ANAQUA SPRINGS RANCH, P.U.D.

MASTER DEVELOPMENT PLAN

Re: **Anaqua Springs MDP** **MDP # 797-A**

The City Staff Development Review Committee has reviewed the Anaqua Springs Development Plan, **M.D.P. # 797-A**. Enclosed, please find a signed copy for your files. Your plan was accepted however please note the following:

ANAQUA SPRINGS RANCH, INC.
ANAQUA SPRINGS RANCH, P.U.D.
MASTER DEVELOPMENT PLAN

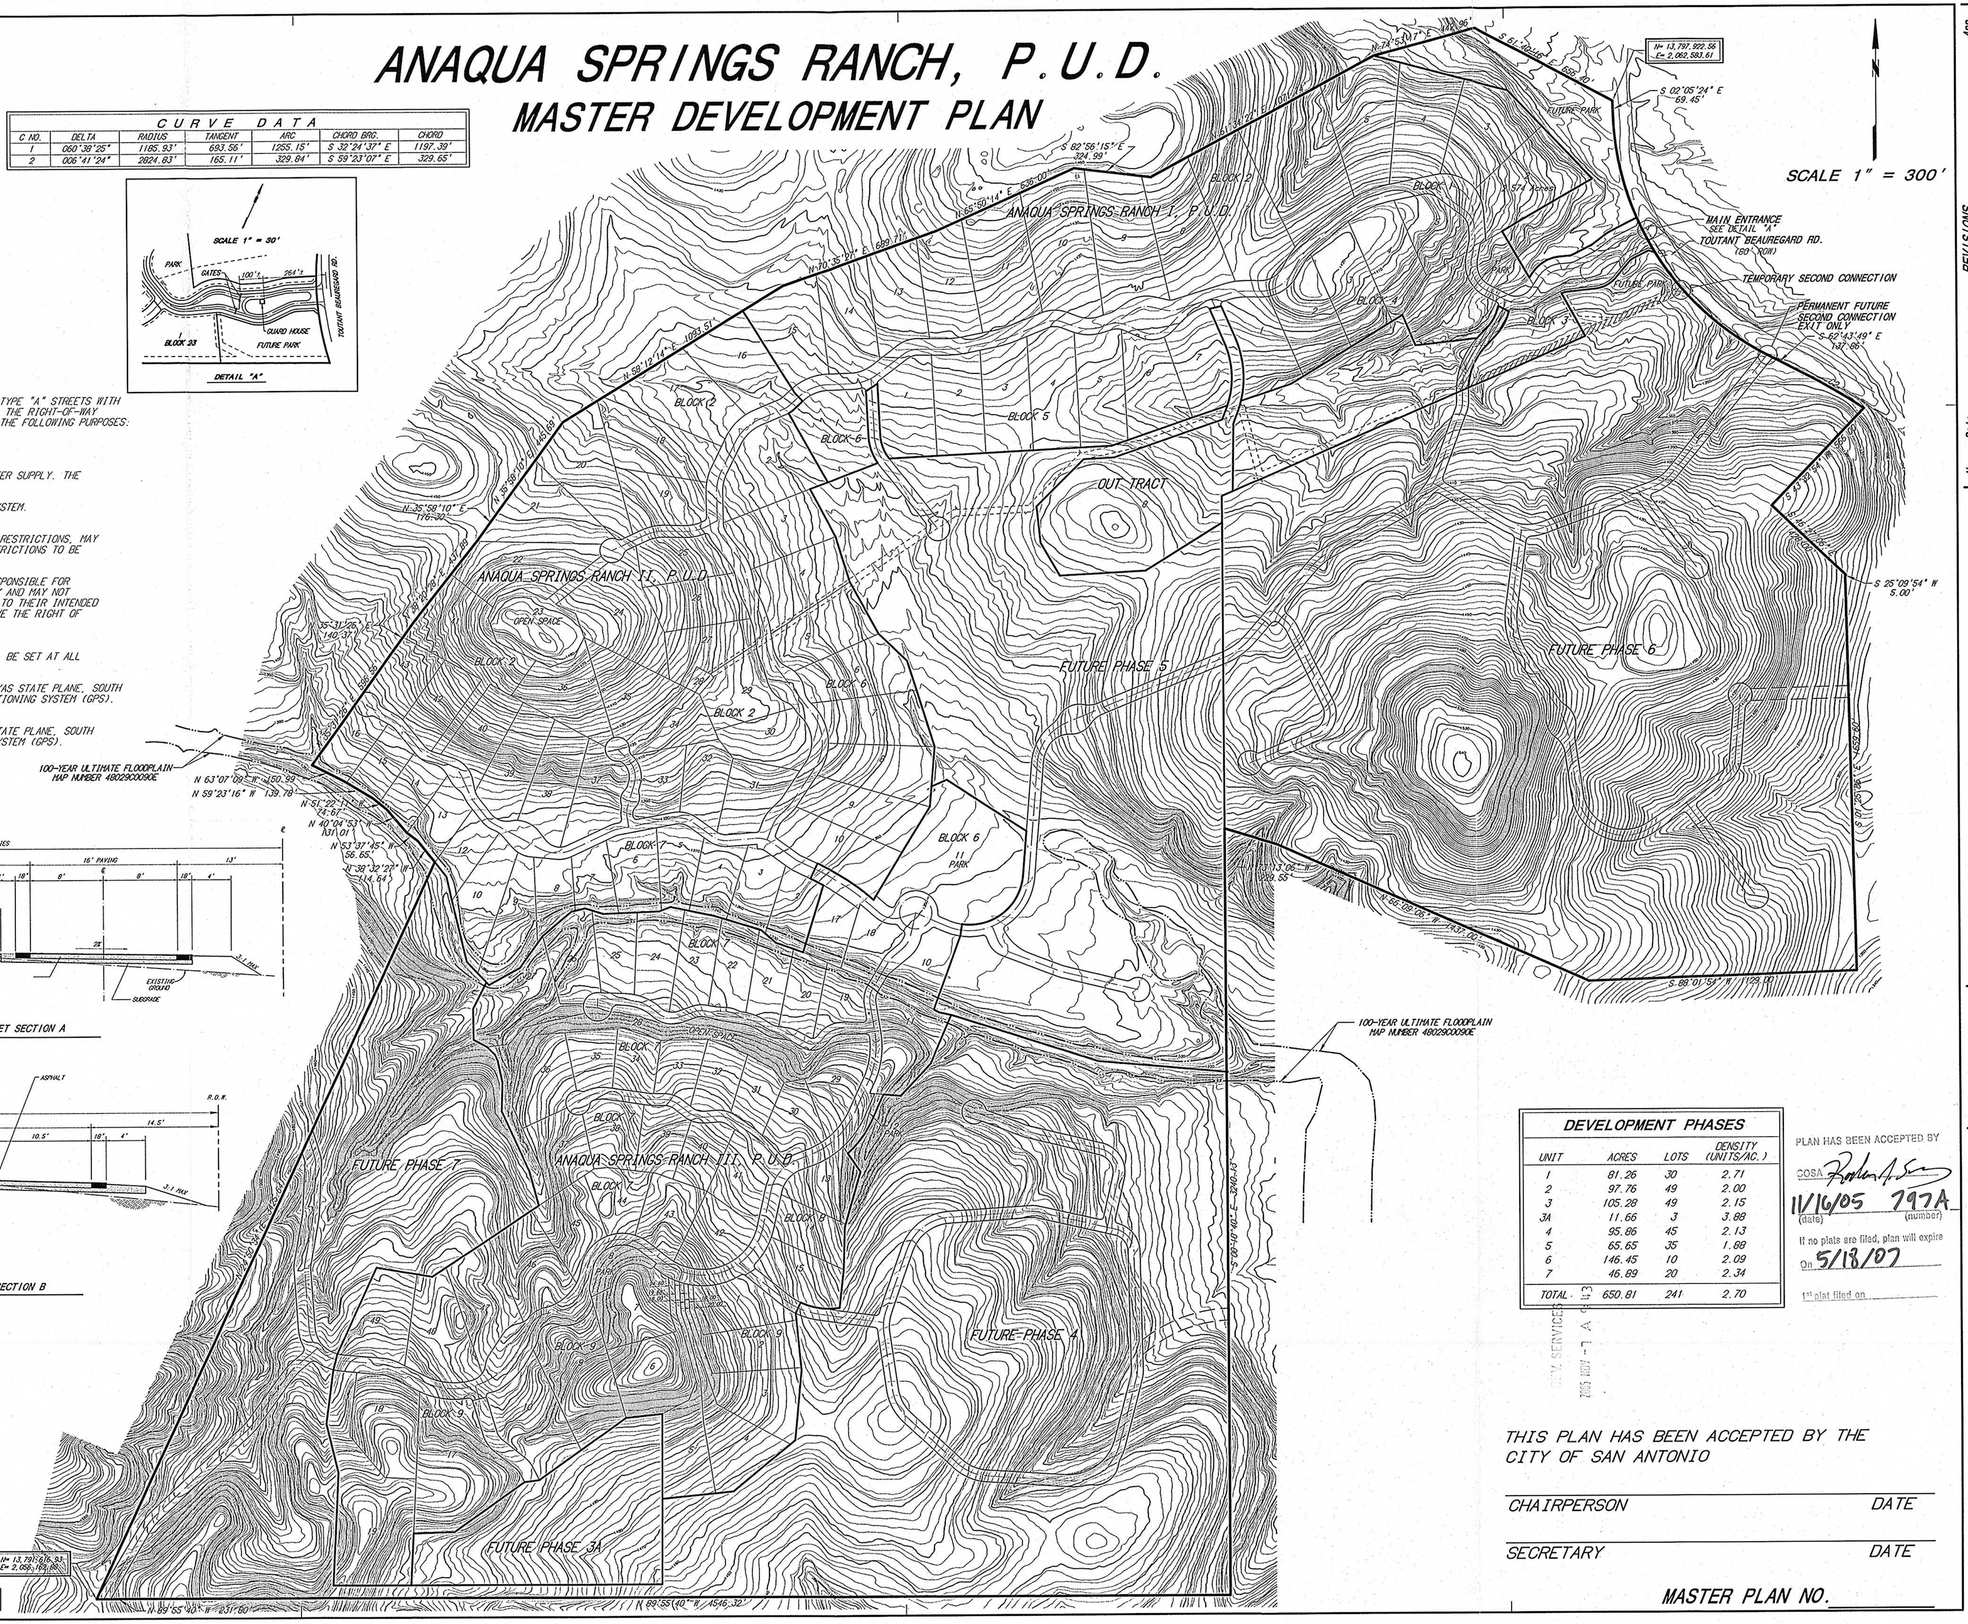
- In consideration of public safety and convenience, excessive grades by reason of topography should be avoided in street layouts and arrangements.

- MDP recommends approval with the condition that two of the projected roadways within the PUD associated with this MDP shall be built at the time of the platting of those phases. These projections are located at the south and southeast edges of the MDP Plan and feed into Phase 4 and 3a.
